# CONSTRUCTION CONTRACT CHANGE ORDER NUMBER: 003

**CCSJ:** 0912-31-304  
**Project:** STP 1702 (437) MM  
**Highway:** CR 58  
**County:** Brazoria  
**District:** Houston  
**Contract Number:** \_\_\_\_\_

**Project:** CR 58 Widening From CR 48 to Sav

Document Type: Change Order Memorandum  
Subject: Change Order 03  
Project: 0912-31-304; CR 58  
Description: Sanitary Sewer Casing Placement

**3 STEEL PIPE CASING**

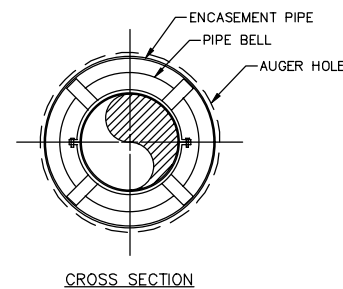
The CR 58 project has a sanitary sewer relocation that is joint bid within the construction project. The relocation is shown on the attached plan sheets 187-197. The plan sheets have a trenchless placement method for lines that cross roadways, however they are not shown to be cased. The County requirements state that crossing underneath County roadways must be cased. Therefore, this change order is to add steel casing underneath the County roadway crossing shown on the attached plan sheets.

The Contractor has submitted a price of \$48,588.27 to complete the casing installations which breaks down to a unit price of \$141.93/LF. The required casing is a 12" steel casing to cap the well and remove the septic system. The County has reviewed the pricing submitted and determined it to be fair and reasonable for the work required.
